Community Meeting #4
April 29, 2014

Verbatim Response Form Comments

Is there anything you would like the Camp Creek Drainage Improvement Project Team to know and understand about the Recommended Plan?

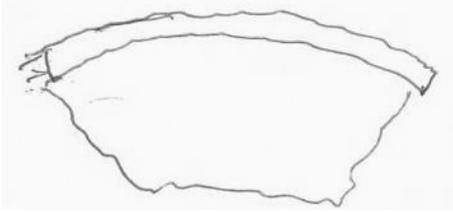
2. Pedestrians and cyclists will be in the middle of 2 driving lanes when the open stream and path end. I believe that will be where the water will go underground. Those non-motorized users will not disappear at that point. In fact, if there is a lot of use there may be several walkers and bicycles. There needs to be a well-planned and large collector for those folks as they want to cross to the side. A good well-marked and even possibly electronically controlled crossing needs to be engineered for safety and comfort of users.
Work to complete the trail / route to connect to Midland Trail at the time of this project.
Concern for the street crossing coming off of Garden of the Gods into the path in the middle of the 2 drive lanes. Needs to be a well-constructed controlled crossing.
